Purpose

The purpose of this memo is to document PJM's concerns with Monitoring Analytics' Effective Load Carrying Capability Senior Task Force (ELCCSTF) proposal to remove the performance observations associated with Winter Storm Elliott (WSE), December 22-24, 2022, and Polar Vortex 1 (PV1), January 6-8, 2014, from the resource adequacy risk and accreditation analysis. Removal of these observations significantly reduces overall risk in the model and results in a large shift in risk from the winter to the summer which will substantially change the Forecast Pool Requirement (FPR) and Accredited UCAP (AUCAP) factors. The rationale provided in support of this proposal is the belief that the scheduling actions PJM took during the January 2025 cold weather event will mitigate most, if not all, large-scale correlated outage events in the future. However, a conservative approach to scheduling the system in anticipation of potential, extreme weather events that are forecasted far enough ahead of time, such as was the case in January 2025, is far from a new concept. The advance scheduling steps PJM took in this instance likely had some effect on resource performance as hypothesized later in

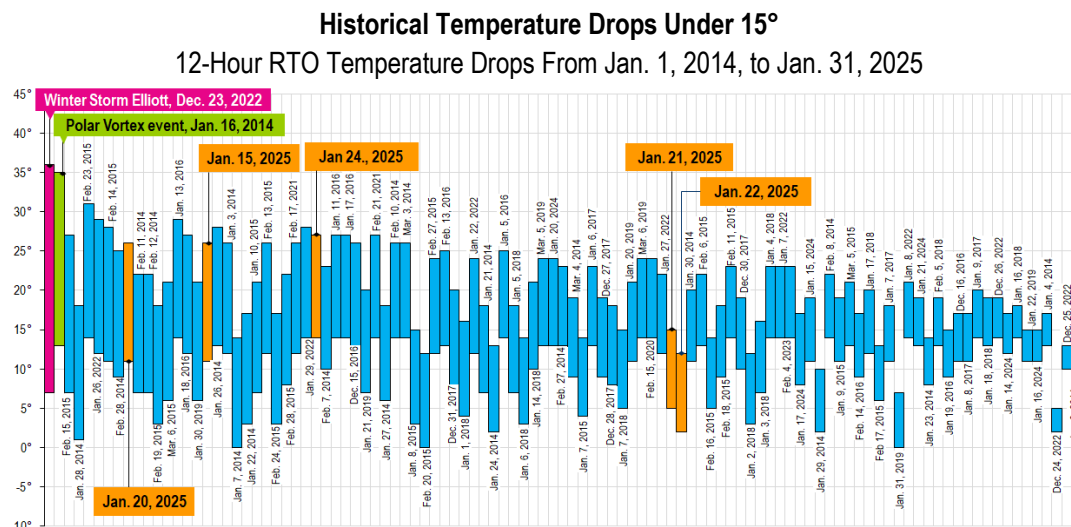
A further factor differentiating January 2025 with WSE and PV1 is the temperature drop over time experienced in these events. The graphic below was posted originally as part of the [Cold Weather Update to the March 2025 Markets and Reliability Committee](#) and highlights the differences between these events. The RTO temperature dropped approximately 30 and 22 degrees over 12 hours during WSE and PV1, respectively, while only about 15 degrees in a 12-hour period in January 2025. The specific weather patterns around these events is important and this data shows that January 2025 had a materially different weather pattern than WSE or PV1.

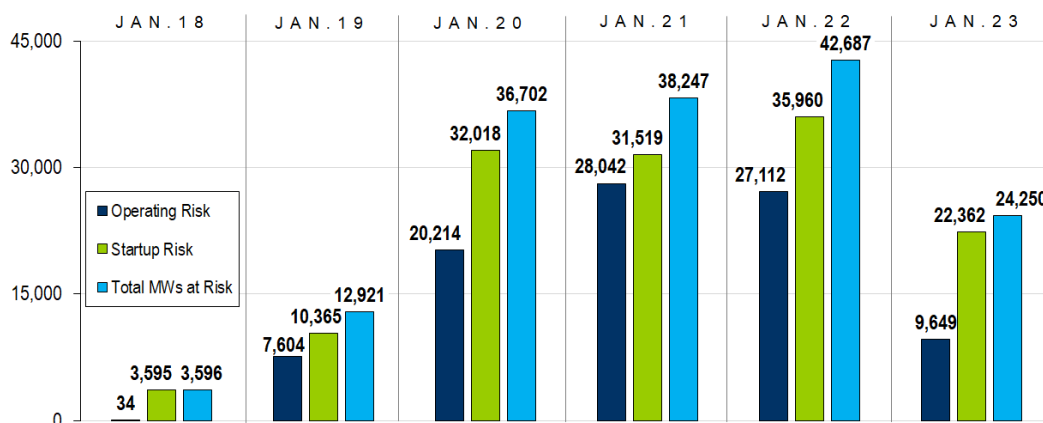
Even with PJM's conservative scheduling in January 2025, the peak forced outage rate during this period reached almost double the annual average.

The average EFORD calculated for the [3rd Incremental Auction for the 2024/2025 Delivery Year](#) was 5.10%. The peak forced outage rate experienced during the January 2025 cold weather event was almost double that at 9.24% as shown on slides 44 and 45 of PJM's [Cold Weather Update to the March 2025 Markets and Reliability Committee](#).

Generation MWs at Risk During January 2025

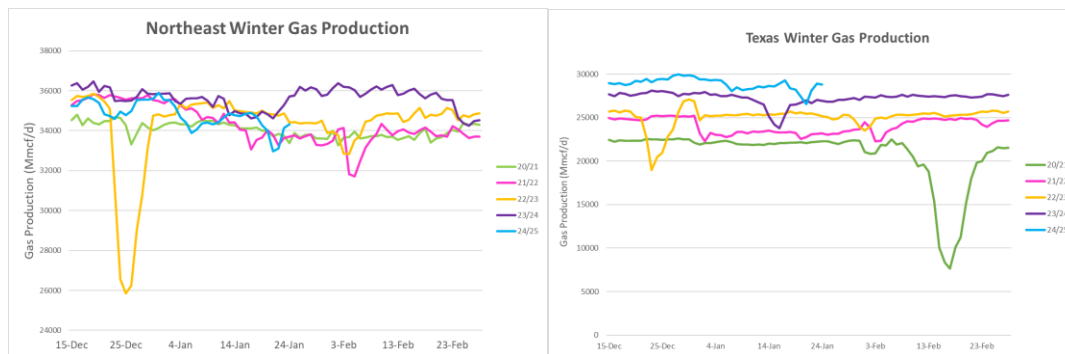
Following WSE and in response to Recommendation 1(f) in the FERC, NERC and Regional Entity Staff Report, "[Inquiry into Bulk Power System Operations December 2022 Winter Storm Elliott](#)", PJM began surveying generation owners for their Cold Weather Operating Limits (CWOL) which were used during the cold weather operations in January 2025. The results of that survey indicate that up to 28,000 MW of generation resources are at risk during their operating cycle (dark blue) is distinguished from startup and fuel-related risks.

As demonstrated by the CWOL report, a significant number of generators have risk of failure when they are already operating. This means they have already purchased fuel and completed the start cycle. This risk of failure falls

outside the bounds of any mitigation step that PJM took in its conservative scheduling in January 2025. It is unclear to PJM how to align this information with the proposal to remove WSE and PV1 performance observations.
